ALAMEDA COUNTY
HEALTH CARE SERVICES

February 26, 2008

Subject: SLIC Case RO0002952 and Geotracker Global ID SL0600101555, Hanson Aggregates Radum Plant, 3000 Busch Road, Pleasanton, CA 94566

TECHNICAL COMMENTS ON LFR WORK PLAN

Attachment A - Revised Monitoring Well Locations

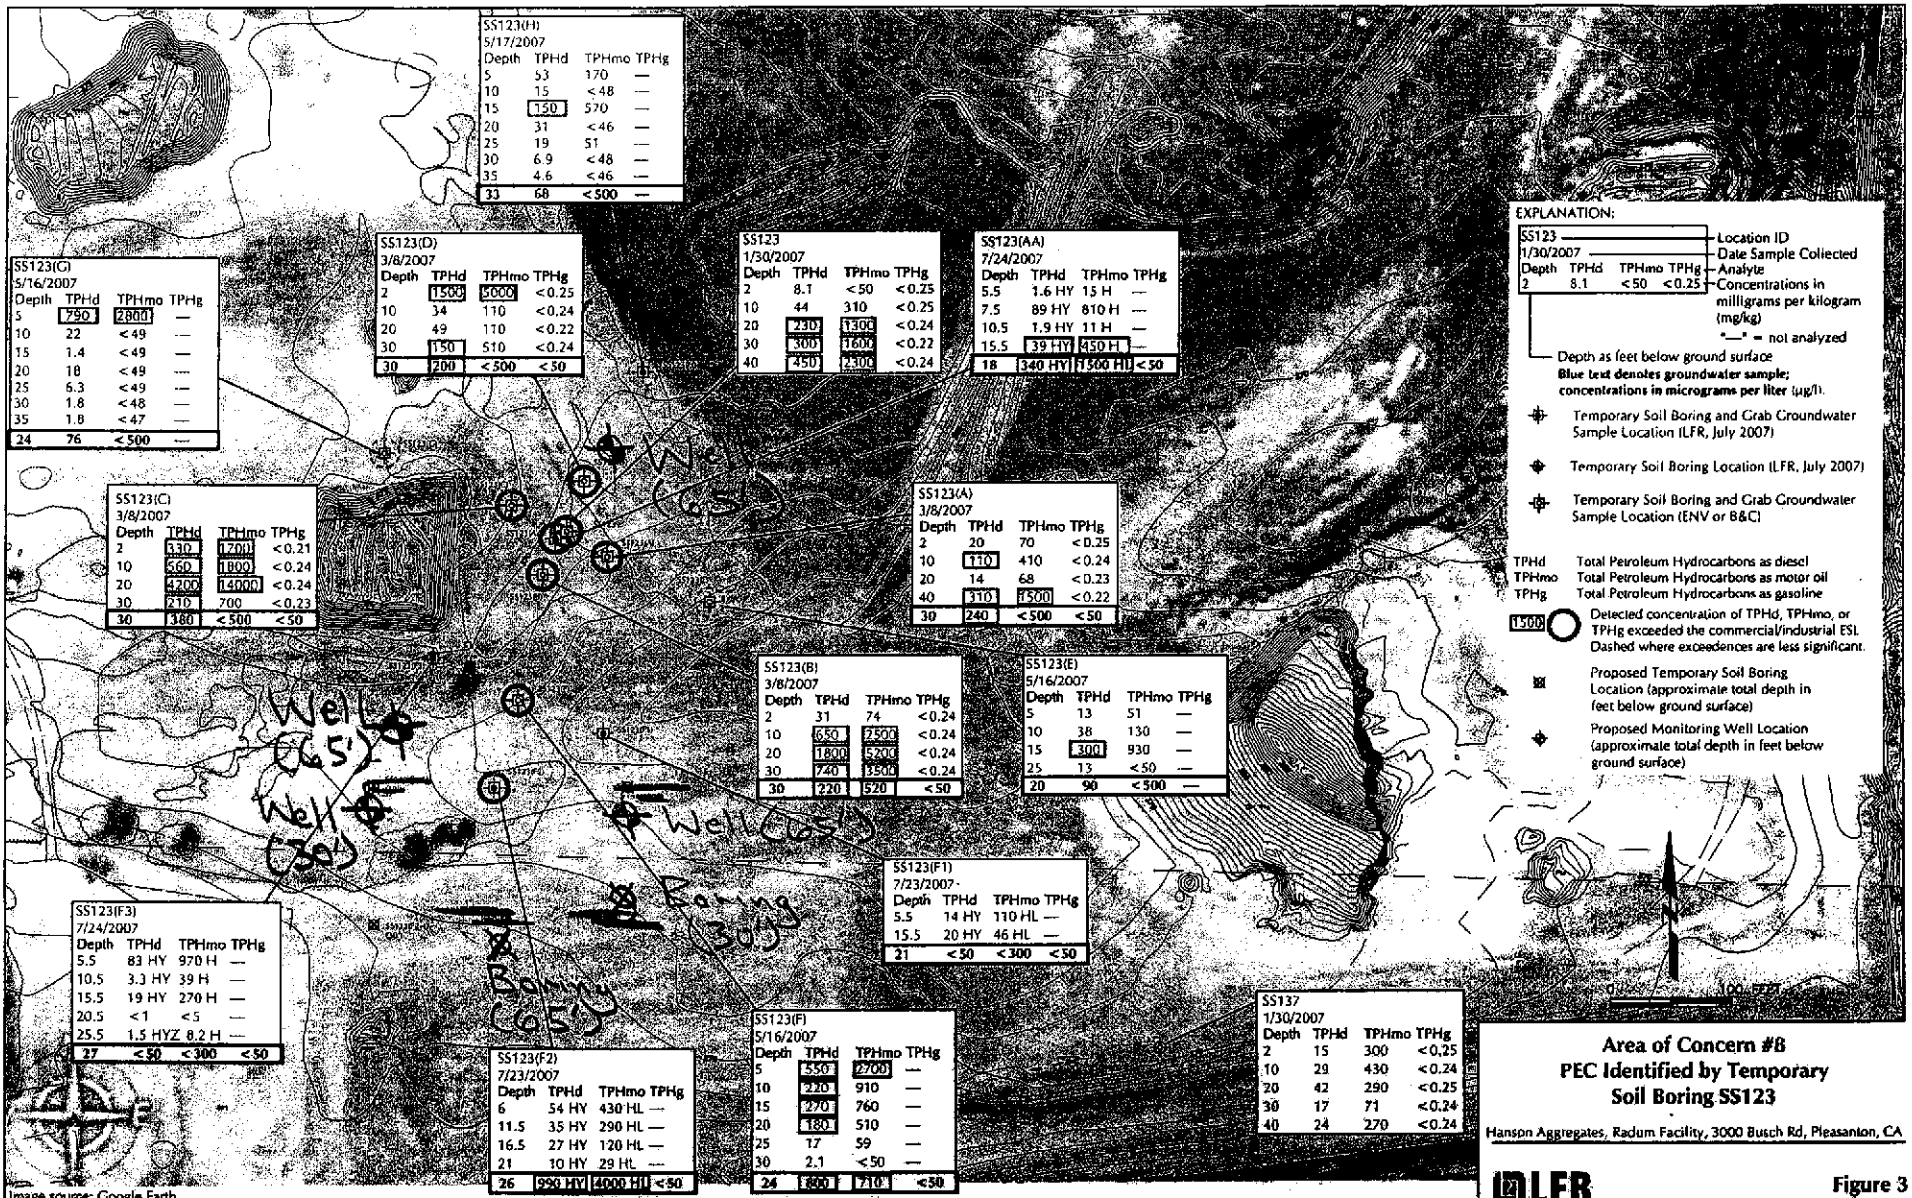
1. **Proposed Monitoring Wells.** The Work Plan currently proposes installation of two monitoring wells south of the existing soil borings for horizontal delineation. The groundwater flow direction in AOC #8 is unknown. However, the regional hydraulic gradient in the Upper Aquifer as shown on Livermore-Amador Basin Groundwater Contour Maps prepared by the Zone 7 Water Agency is generally to the north or northwest. The hydraulic gradient in AOC #1 is to the northwest based upon water levels measured in recently installed monitoring wells in AOC #1. Cope Pond and Lake I are north and northwest, respectively, of AOC #8. Based upon this regional information, it appears that the groundwater flow direction in AOC #8 is more likely to be toward the north or northwest rather than south. Therefore, we request that the proposed locations of soil borings and monitoring wells be adjusted as shown on Attachment A – Revised Monitoring Well Locations to install monitoring wells north and northwest of the areas where shallow groundwater contamination has been detected. In order to determine the groundwater flow direction, we request that you install a total of three monitoring wells within the regional aquifer, also shown on Attachment A – Revised Monitoring Well Locations. Please present the results in the AOC#8 Site Investigation Report requested below.
